REMARKS/ARGUMENTS

Application No.: 09/598,372 Amendment dated March 25, 2004

Reply to Office Action dated January 26, 2004

Figure 7

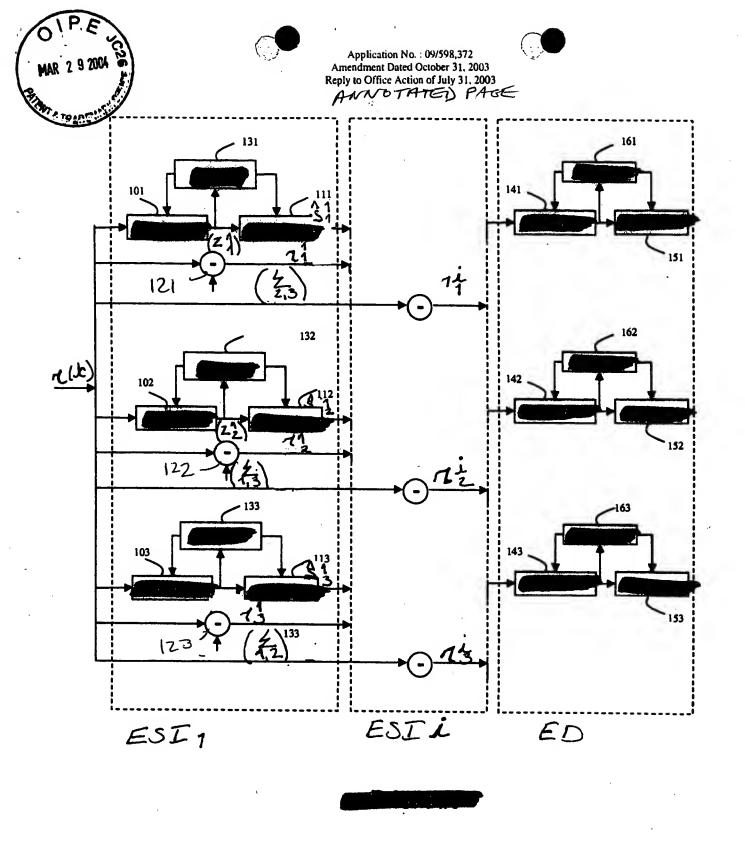
FIGS. 6 and 7 have been corrected to include reference numerals 121, 122, and 123, which were inadvertently omitted from the corrections previously submitted.

Figure 8

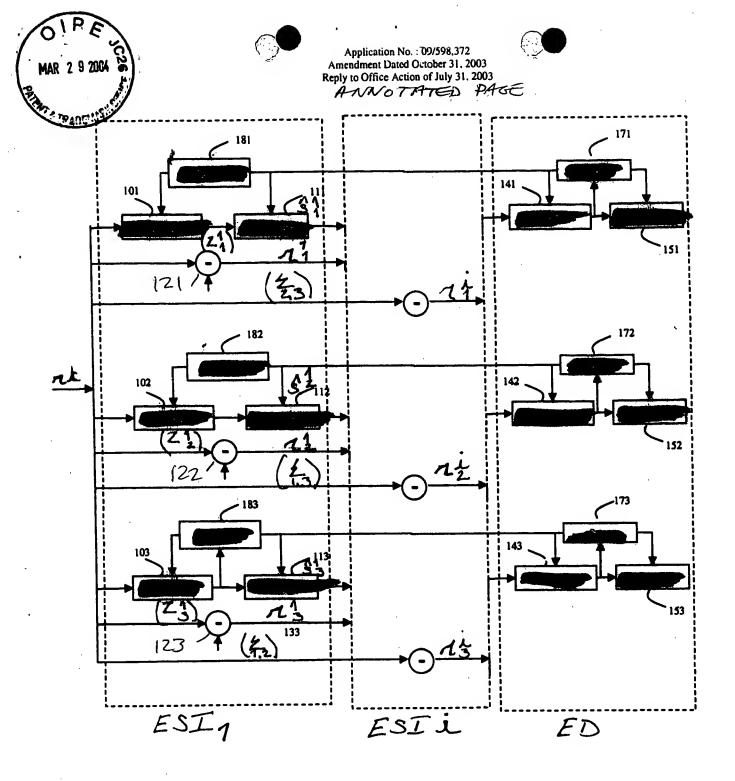
Claims 1-3 were rejected under 35 U.S.C. 112, first paragraph, as failing to comply with the enablement requirement.

with the written description and drawings. Specifically, with reference to FIG. 8, element 171 (or 172, or 173), which is described as a synchronization means (specification, page 11, lines 9-10), is depicted as providing control signals to the interference suppression means ESI_i, ESI₁ (specification, page 11, lines 9-10) and to the decision means 151 (the leftmost arrow emanating from box 171 points to box 151, which is identified as the decision means on page 7, line 33—note that FIGS. 7 and 8 share some elements in common, as is commonly practiced, and as is clearly noted on page 11, lines 6-7, wherein it is stated that "Fig. 8 corresponds to fig. 7 and the same means carry the same references.").

Claim 1 further specifies, in a manner consistent with the remainder of the claim and the written specification and drawings, that "the means for producing the synchronization signals are constituted by K means solely placed in the K channels of the final stage (ED)," (FIG. 8 depicts the means 171, 172, 172 for producing the synchronization signals within the broken-line box labeled ED), and that "the K synchronization signals produced by said K means [control] the K decision means of the K channels of the final stage (ED) and the interference estimation means of the K channels of the at least one interference suppression stages (ESI_i) following appropriate time shifts." The K decision means are means 151, 152, 153, described as such for example on page 7, line 33 (again it is noted that that FIGS. 7 and 8 share some elements in common, as is commonly practiced). The interference estimation means of the K channels of the at least one interference suppression stages correspond to boxes 111, 112 and 113, described as such on page 11, line 17, for example. Time shifts are provided by circuits 181, 182 and 183. These relationships are clearly depicted in FIG. 8, showing appropriate arrows emanating from box 171 and pointing to box 151 in the final stage ED, and further pointing, by way of box 181, to box 111 in interference suppression stage box ESI₁. Based on the foregoing, it is urged that Claims
